Product Change Notification / BLAS-30BRVK558

CCB 6431 Final Notice: Qualification of GTBF as an additional assembly site for selected CL1N8-G, CL25N8-G, CL2N8-G, FP0100N8-G, HV9921N8-G, HV9922N8-G, HV9923N8-G, LND150N8-G, LR645N8-G, LR745N8-G, LR8N8-G and MD0100N8-G catalog part numbers (CPN) available in 3L SOT-89 package.

PCN# BLAS-30BRVK558

LEAD FRAME COMPARISON

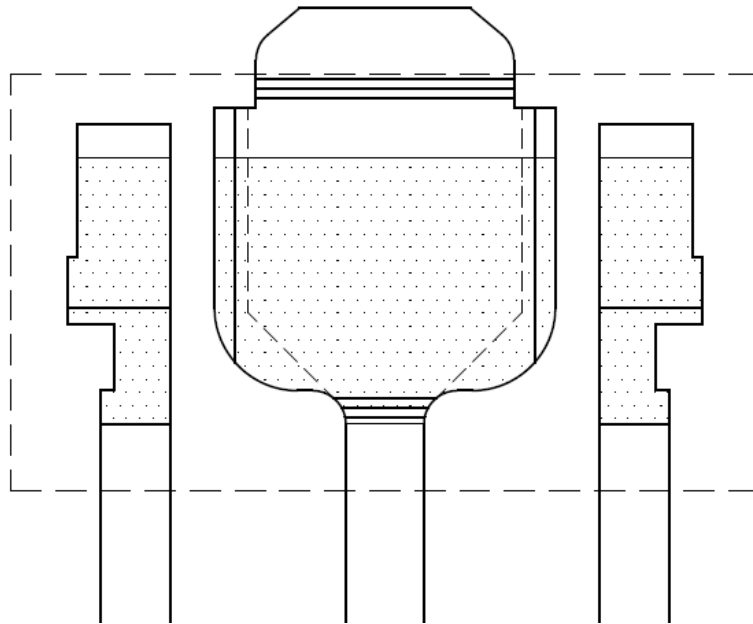
Lead frame Material	KFC
Lead-Frame Paddle Size	79x63mils

GTBF

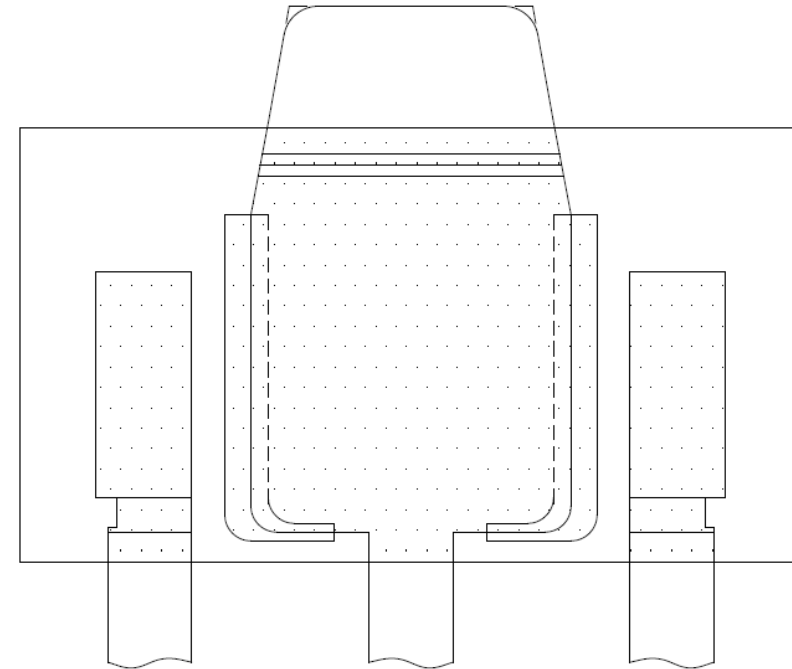
Lead frame Material	KFC/LY89
Lead-Frame Paddle Size	71x79mils
